**RE: Supplemental Geotechnical Review
Proposed Armstrong Estates Residential Subdivision
Mansfield, Ontario
Project No. 2204585**

Supplemental geotechnical confirmation was requested by the Client to address the following two comments (Comments 4 and 5) from the Nottawasaga Valley Conservation Authority (NVCA):

DRAFT PLAN OF SUBDIVISION ARMSTRONG ESTATES OF MANSFIELD

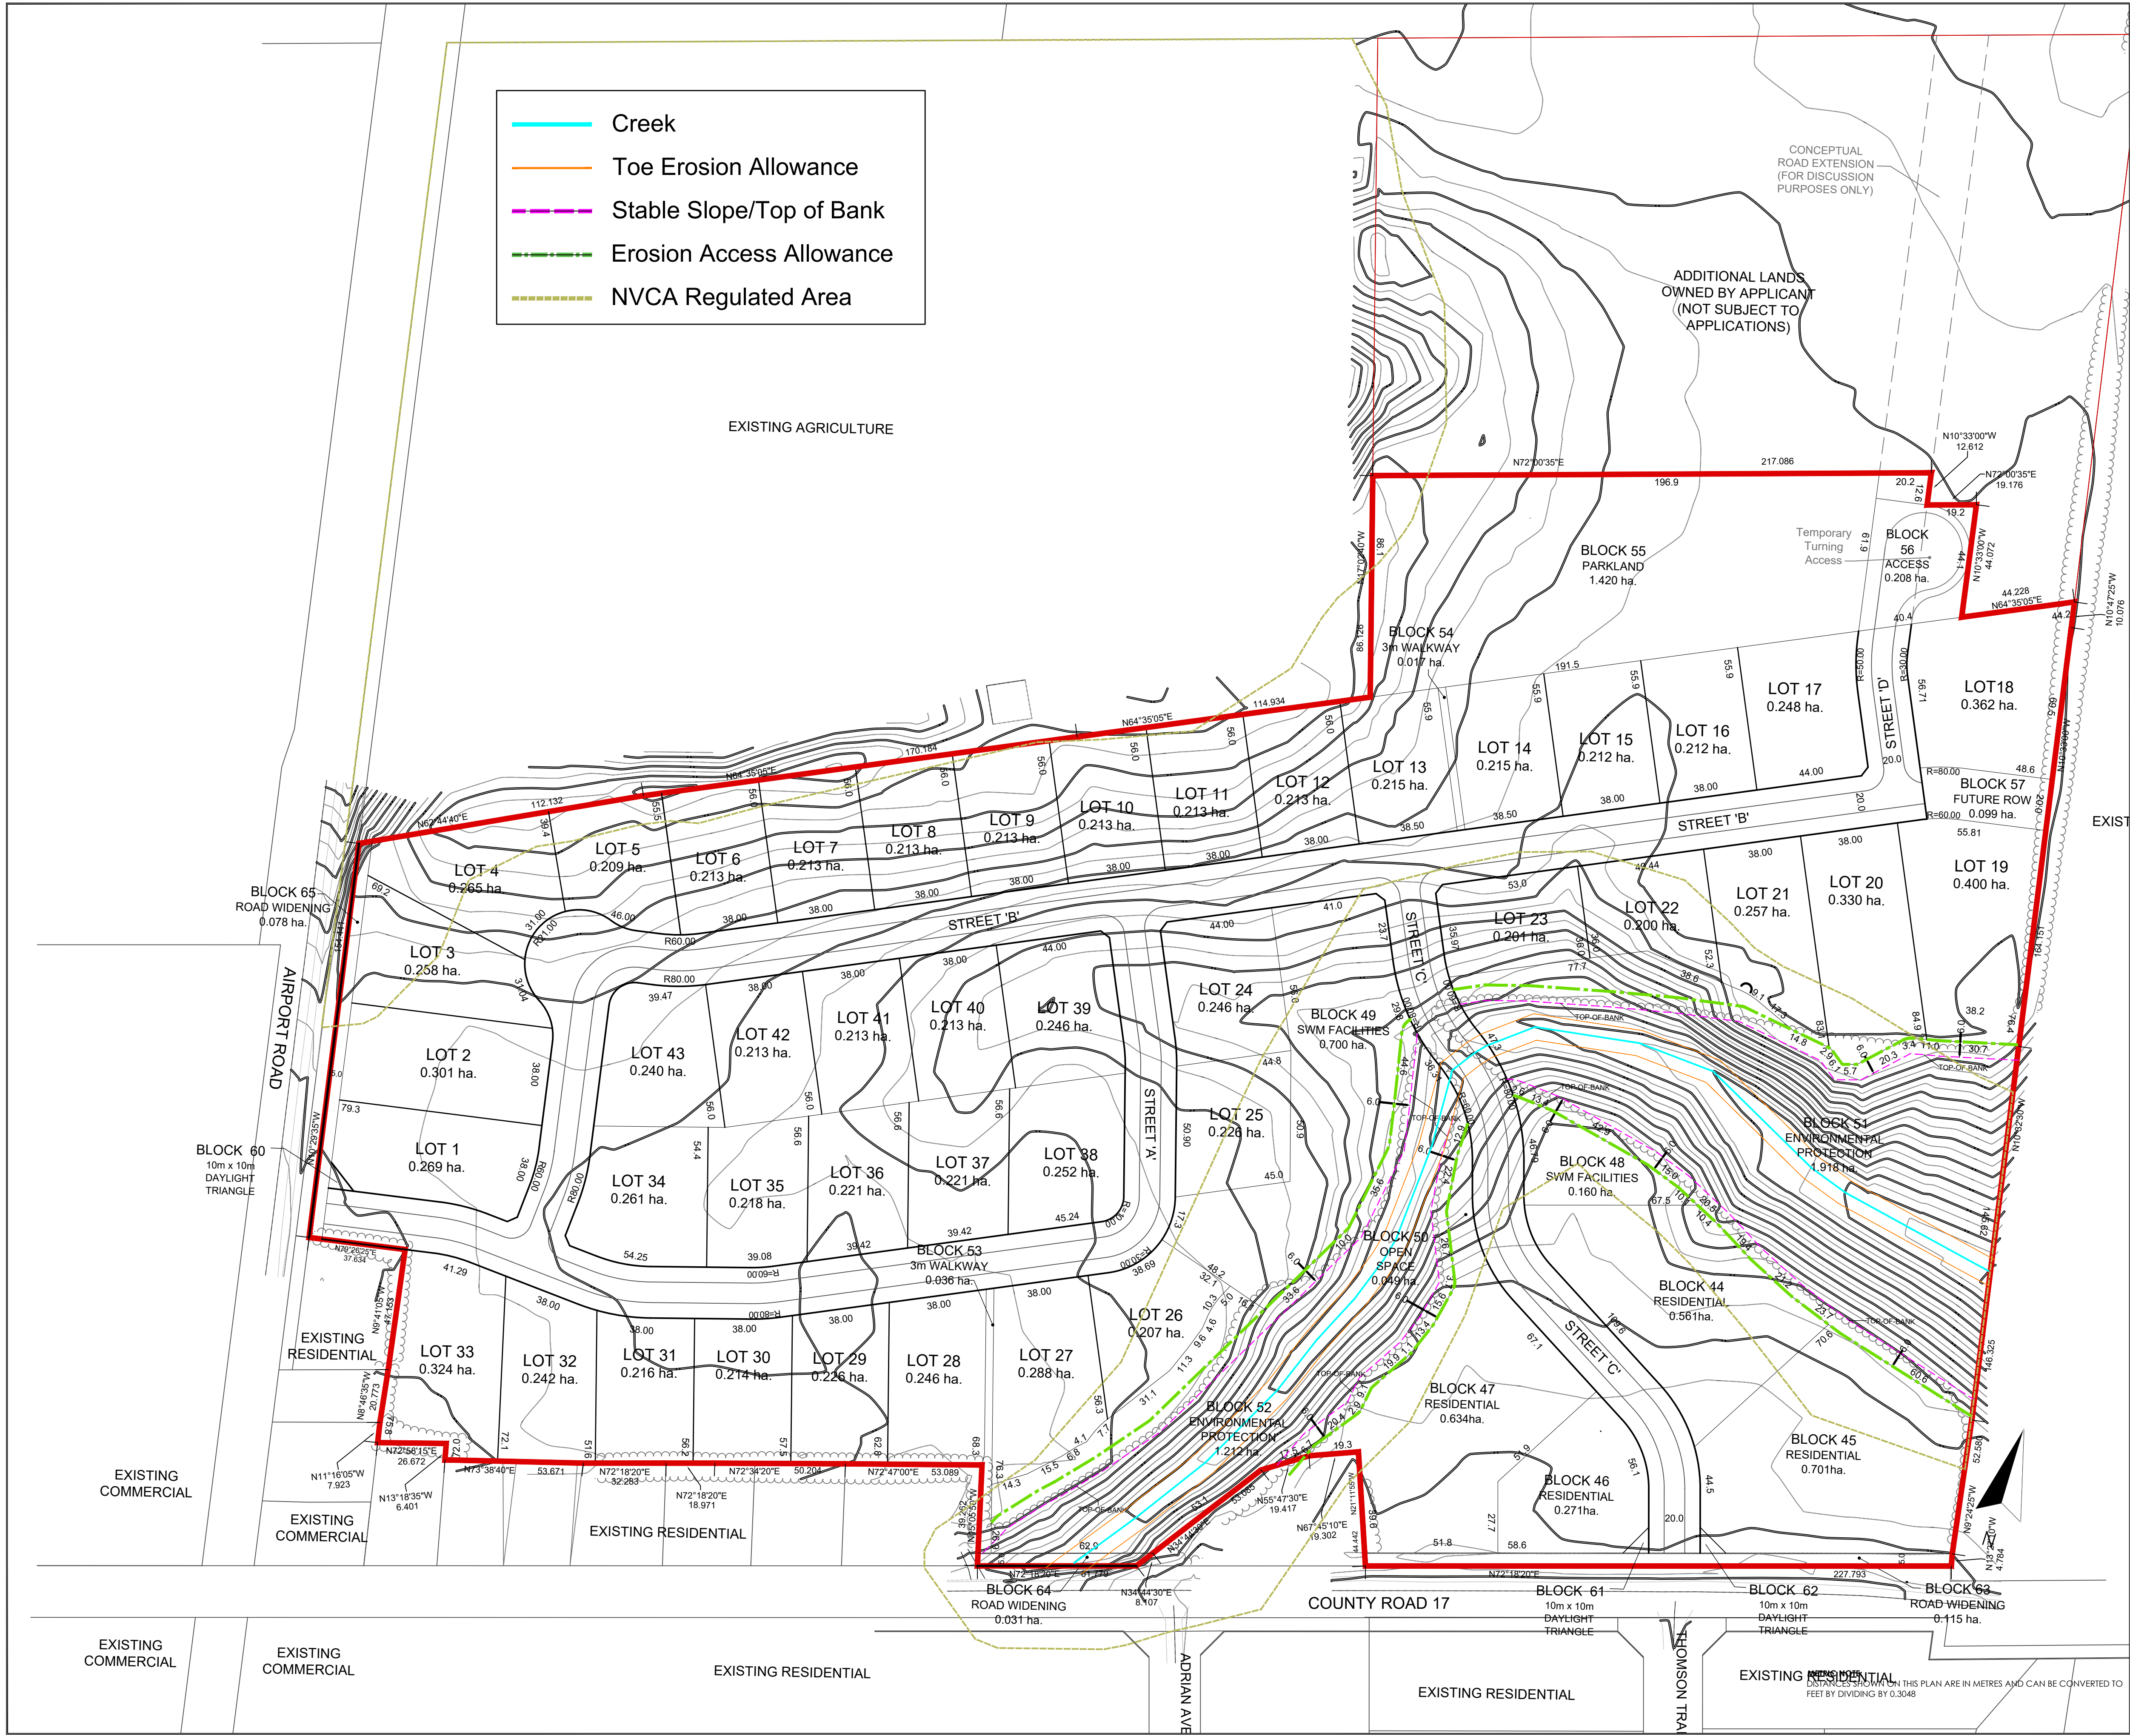
- ***Comment 4:*** *Please provide an existing conditions erosion hazard limit drawing that is signed and sealed by the qualified professional. Please include with a legend that clearly identifies the separate components of the slope erosion hazard limit assessment, including a clearly defined long-term stable top of slope limit line from the assessment, plus a separate 6 m access allowance limit line. This separate information is not clear in several*

locations on the proposed conditions Draft Plan, considering the text provided with the line types.

GEI Response to Comment 4: A PDF of the requested drawing is attached.
